Access Compliance Report

(Curb Ramps)

Intersection ID: 31581	Main Street: BLYTHEDALE_DR	Cross Street: PATTONSBURG_DR	Location: SE
ADA ID: A658E1626D4C	Ramp Type: BlendTrans1	Initial Pass/Fail: Fail	Overall Compliance: No
Severity Score: 8.75			
Codes/Mitigation Info/Possible Solution		Field Measurements/Component Compliance

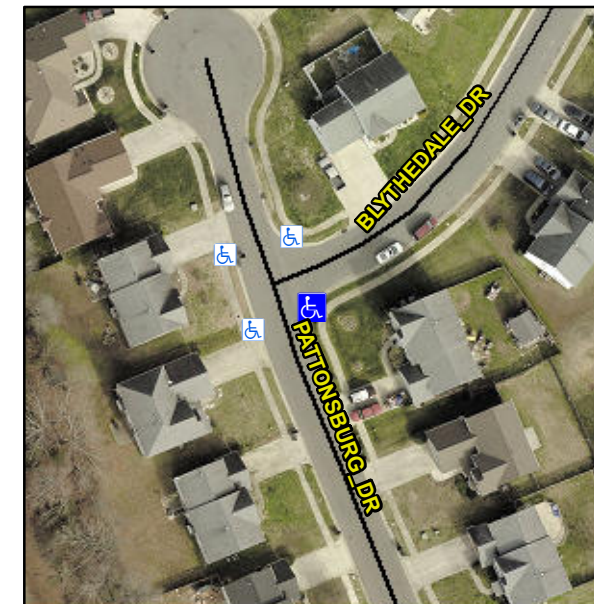
DWS DETACHED

Not Found, R304.5.1

Compliance	Description	Data	Compliance	Description	Data
N/A	Ramp Length (in)	49.0	Yes	BlendTrans Slope (%)	3.5
No	Ramp Width (in)	44.0	Yes	BlendTrans XSlope (%)	0.7
N/A	Flare Type LT	N/A	N/A	Flare Type RT	N/A
N/A	Flare Slope LT (%)	N/A	N/A	Flare Slope RT (%)	N/A
N/A	Flare Traversable LT?	N/A	N/A	Flare Traversable RT?	N/A
N/A	Landing Length (in)	N/A	N/A	DWS Provided?	N/A
N/A	Landing Width (in)	N/A	N/A	DWS Contrast?	N/A
N/A	Landing Slope (%)	N/A	N/A	DWS Length (in)	N/A
N/A	Landing X Slope (%)	N/A	N/A	DWS Full Width?	N/A
N/A	Landing Curb? (Y/N)	N/A	N/A	DWS Offset (in)	N/A
N/A	Shared Landing?	N/A			
N/A	Gutter Ponding?	N/A	N/A	Gutter Slope (%)	N/A
N/A	Gutter Lip Ht (in)	N/A	N/A	Gutter X Slope (%)	N/A
N/A	Painted X Walk1?	No	N/A	Painted X Walk2?	No
	X Walk 1 Direction	To N		X Walk 2 Direction	To W
	X Walk 1 Width (in)	N/A		X Walk 2 Width (in)	N/A
	X Walk 1 Slope (%)	3.0		X Walk 2 Slope (%)	2.9
	X Walk 1 X Slope (%)	1.1		X Walk 2 X Slope (%)	3.3

Remove & Replace Curb Ramp With Two New Directional Ramps or Equivalent.
